ALERT SERVICE BULLETIN

NO. 205B-01-35

SUBJECT: MAGNETIC BRAKE P/N 204-001-376-003, ONE TIME INSPECTION OF.

FIGURE 1

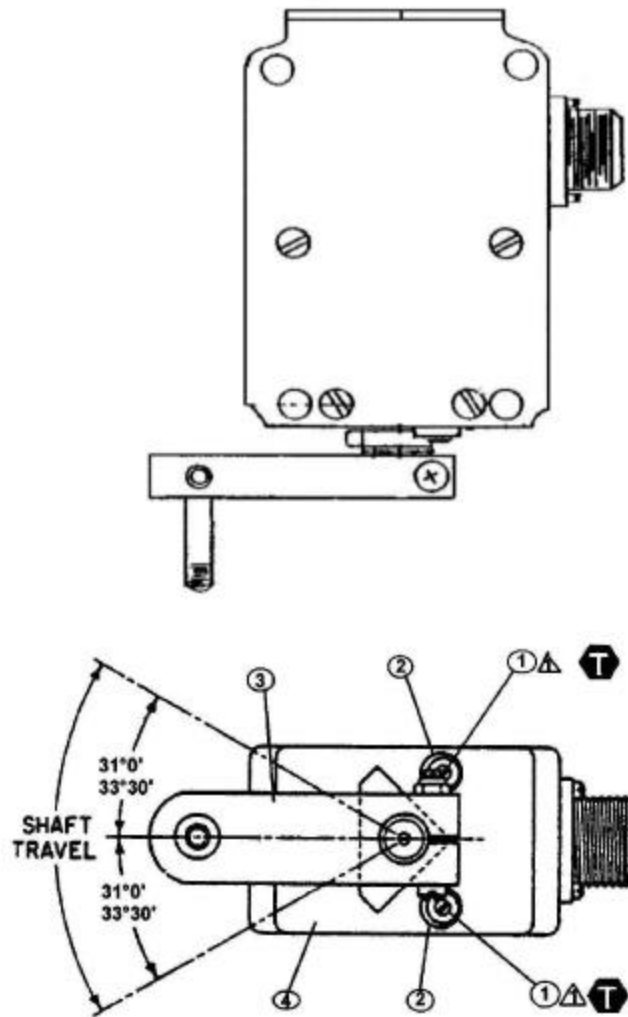
6. Using a suitable torque wrench and screw driver bit apply 10 inch/lbs (1.12 Nm) force to screw(s) (1, figure 1) in a counterclockwise direction. If screw(s) (1) do not move, proceed to step 12. If any movement is found on screw(s) (1) proceed to the following steps.

If the inspection reveals that screw(s) (1) has disengaged, inspect arm assembly (4) for mechanical damage created by screw(s) (1). If mechanical damage is found, the depth shall not exceed 0.030 inch (0.762 mm). Acceptable damage may be smoothed and treated in accordance with the Standard Practice Manual Chapter 3 for Chemical Film. If damage is greater than 0.030 inch (0.762 mm) contact Product Support Engineering.

7. Remove screw(s) (1) and stop limit(s) (2) from magnetic brake (4).

8. Clean residue adhesive from magnetic brake (4) screw holes and screw(s) (1) with compressed air.
9. Apply adhesive (C-320) to screw (1) threads and install in magnetic brake (4) hand tight.
10. Adjust the stop limit(s) (3) to achieve the arm assembly shaft travel as per dimensions in BHT-205-MM Maintenance Manual, Chapter 27.
11. Once shaft travel is obtained, torque screws (1) 5 to 10 in-lbs (0.56 to 1.12 Nm).
12. Apply torque seal inspection ink to screws (1) and to stop limits (2).
13. Re-install cyclic fore & aft and lateral magnetic brakes into aircraft.
14. Re-install cyclic and anti-torque magnetic brake access panels.
15. Connect battery.
16. Make an entry in the helicopter historical records indicating compliance with this Alert Service Bulletin.

-  Bond screw with adhesive C-320
-  5 to 10 IN-LBS
(0.56 TO 1.12 Nm)
